Addendum 02
SFISD RJ Wollam Elementary School
& Santa Fe Junior High School
Generator Installation

18 April 2022

This addendum modifies the original Proposal Documents dated March 25, 2022 and forms a part of the Contract Documents. Acknowledge receipt of this Addendum in the space provided on the Proposal Form. Failure to do so may subject Proposer to disqualification.

ES-M2.0

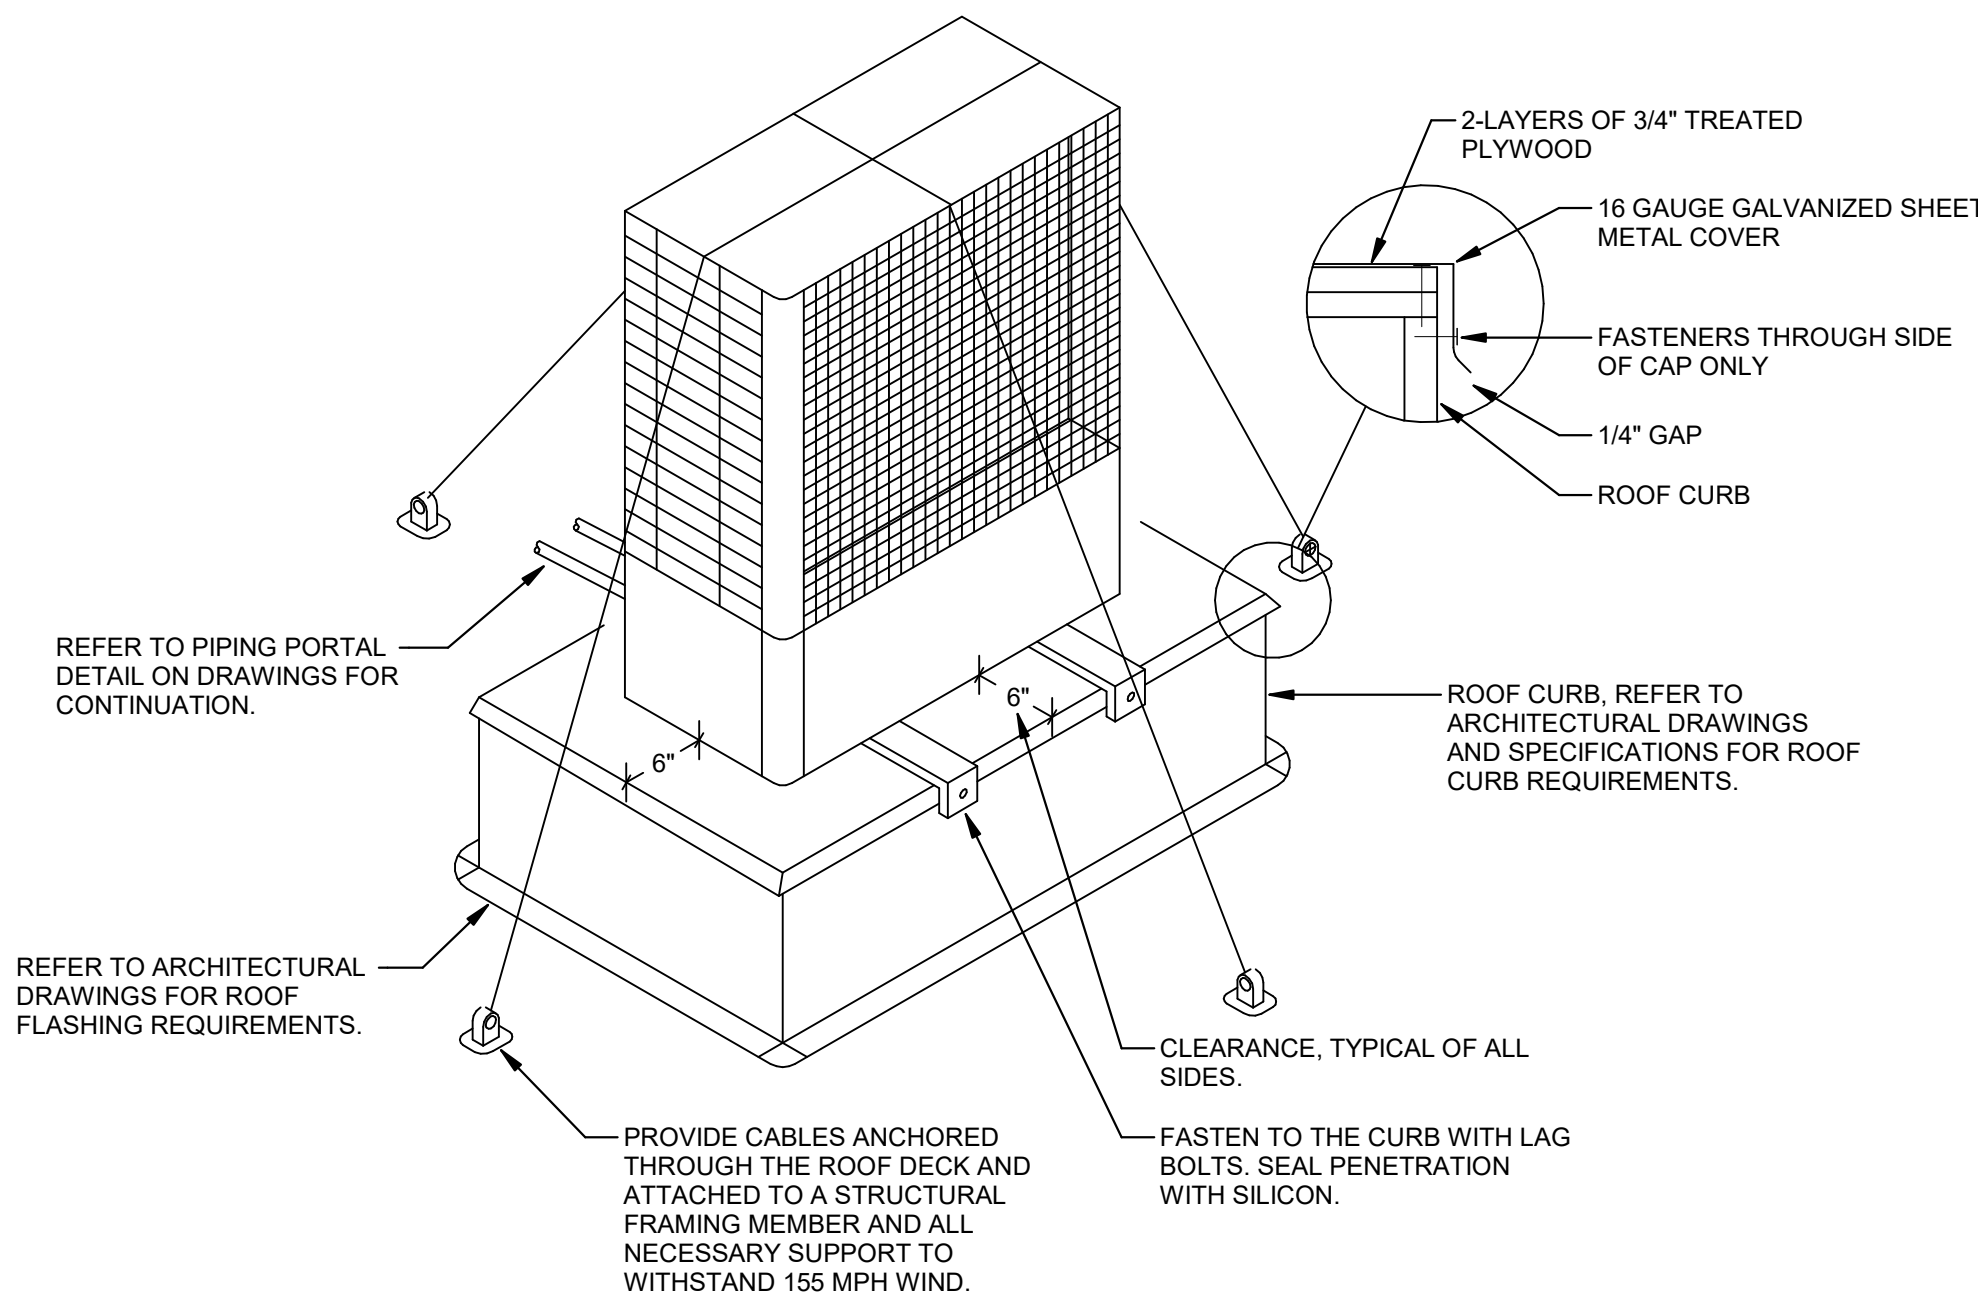
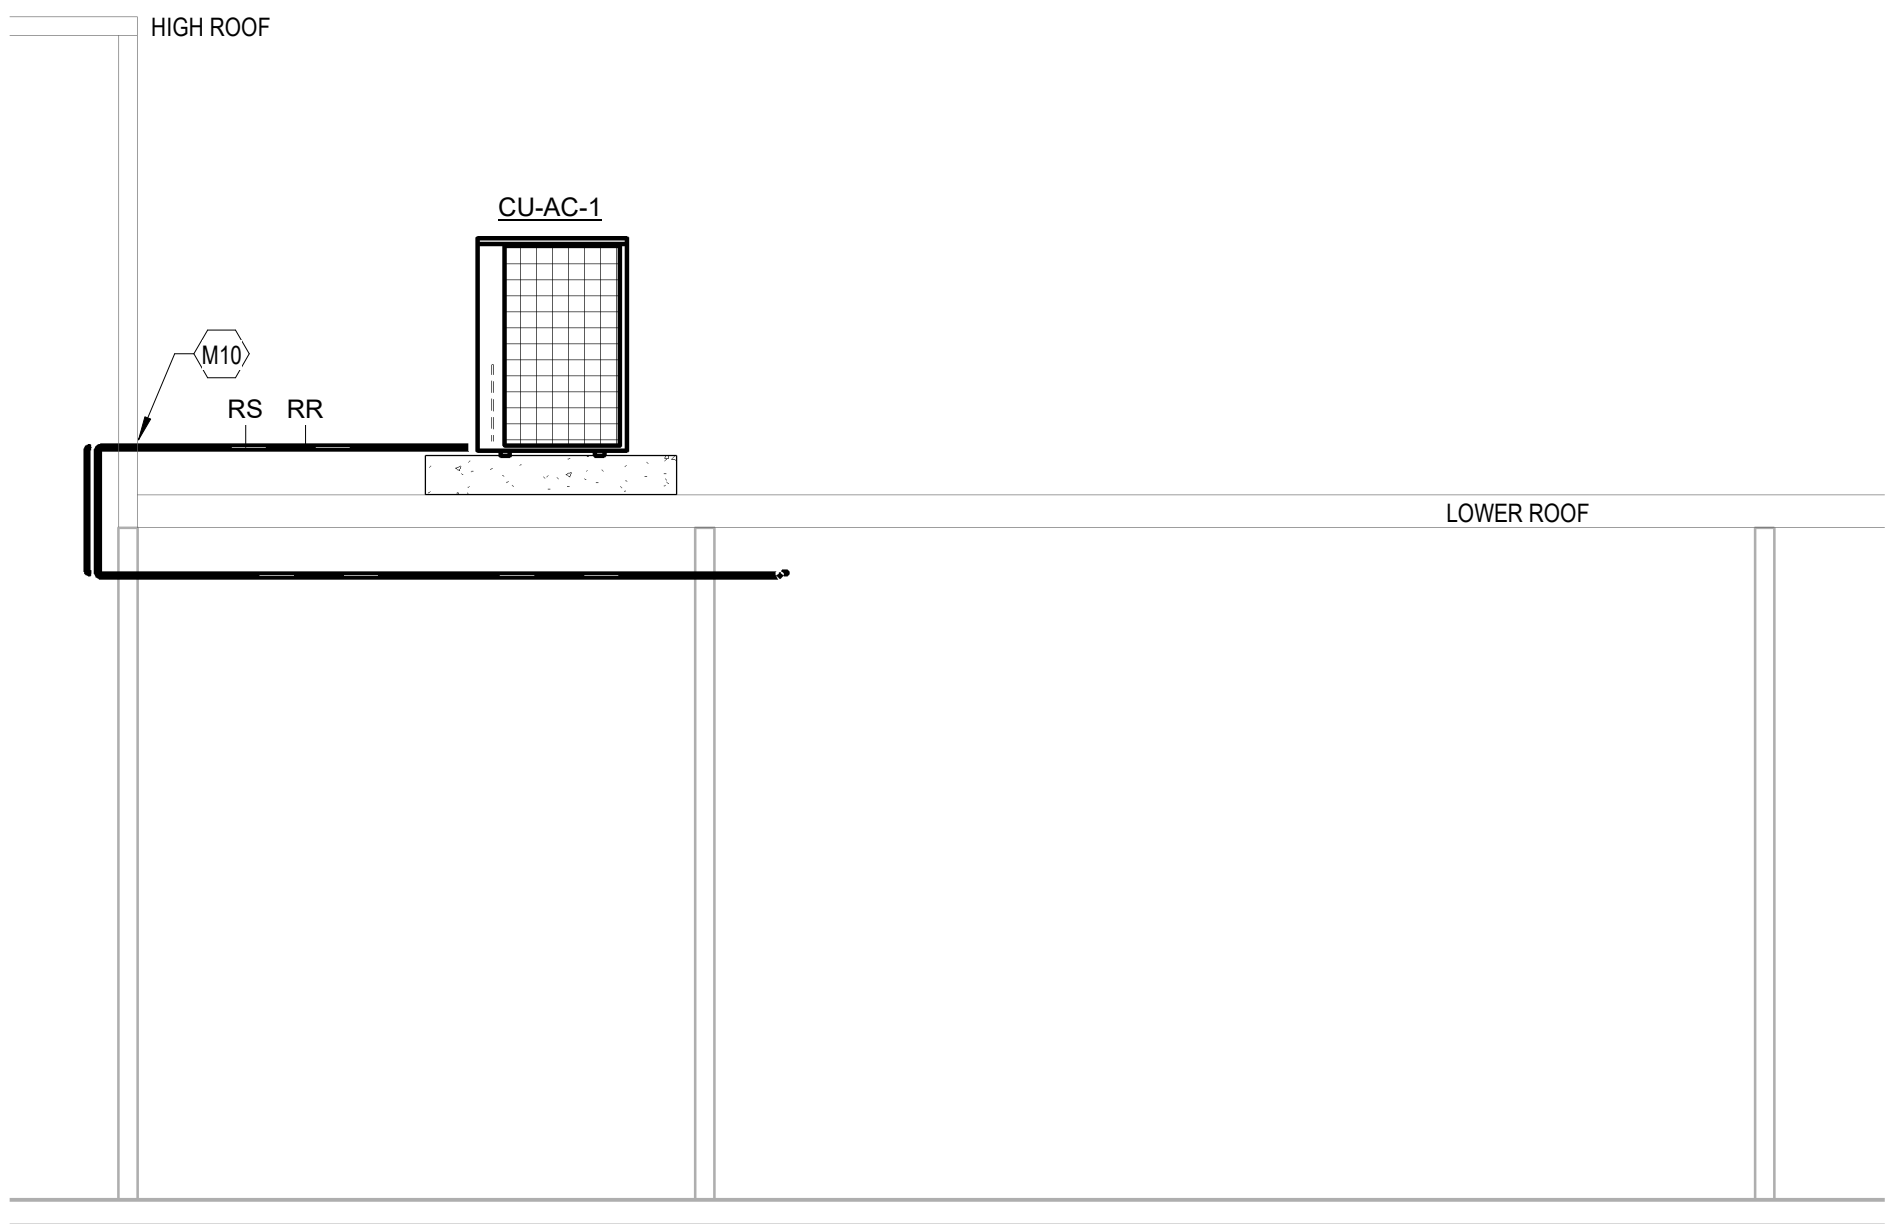
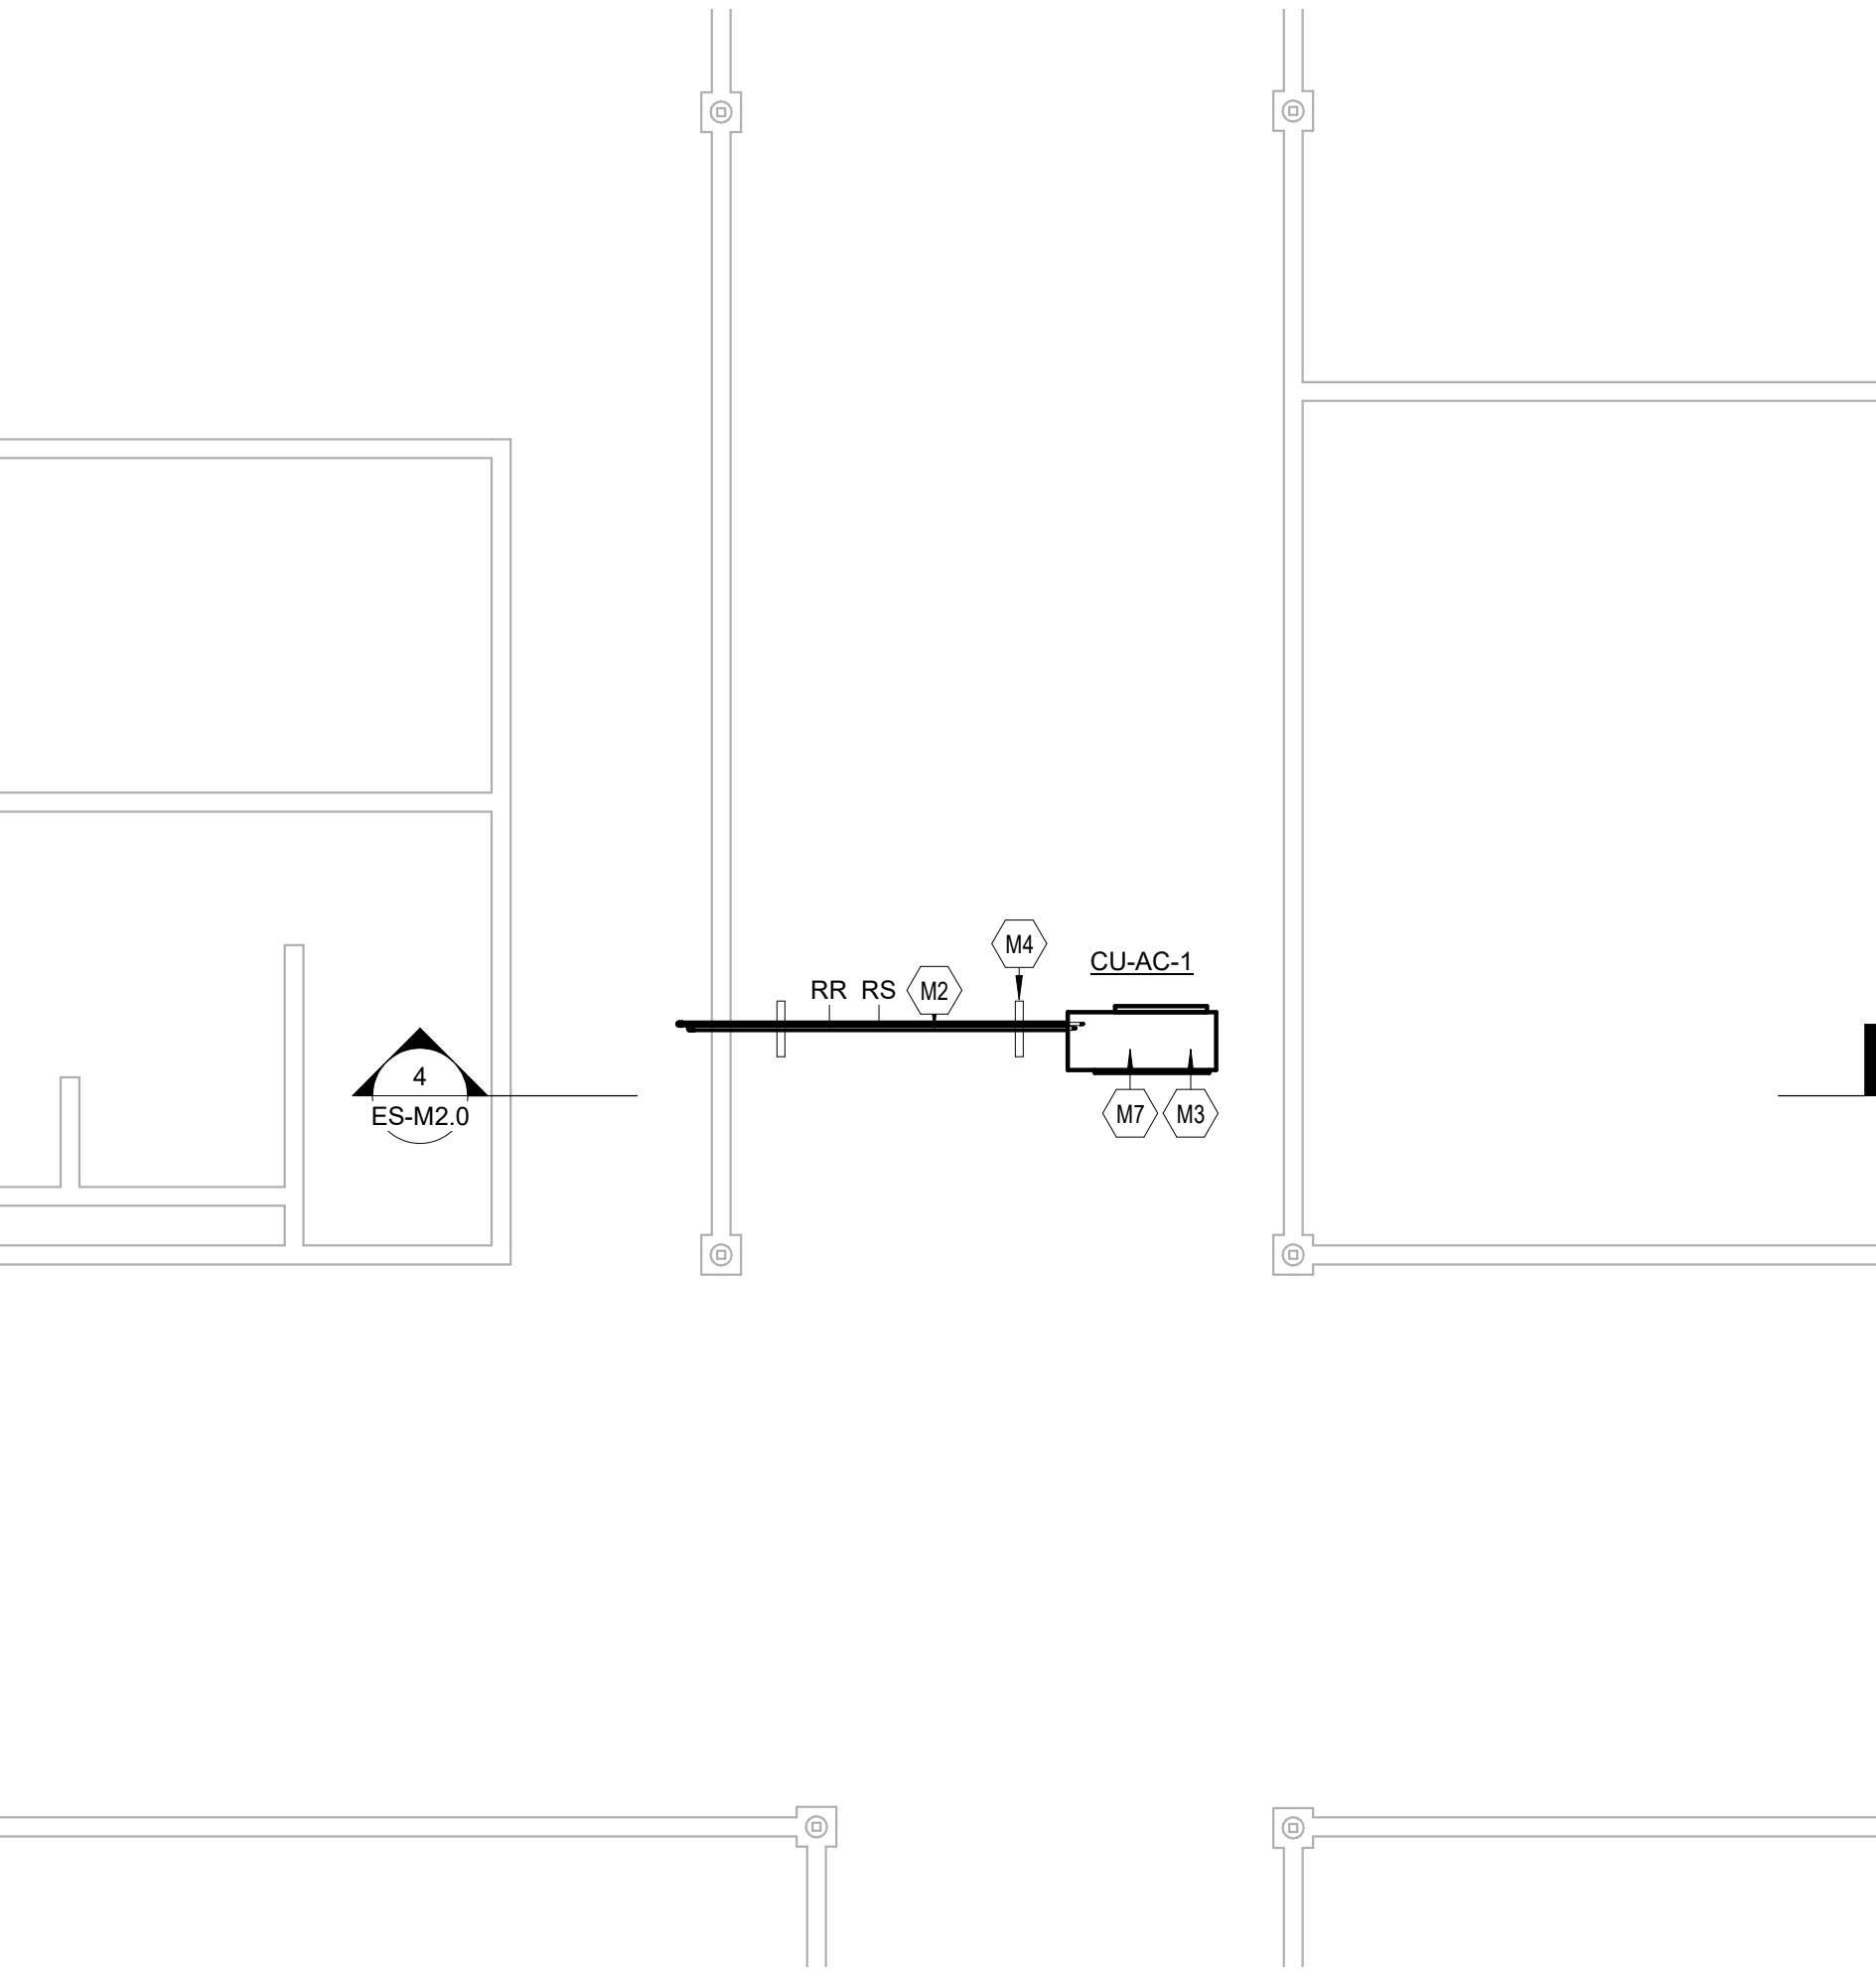
- 03 ES-M2.0 MECHANICAL ENLARGED ROOMS AND DETAILS:
 - a. Removed view 3/ES-M2.0 from the project and cooling towers VFD's is existing to remain.
 - b. Removed VFD's detail from the project as noted above and tagged note M8 accordingly.
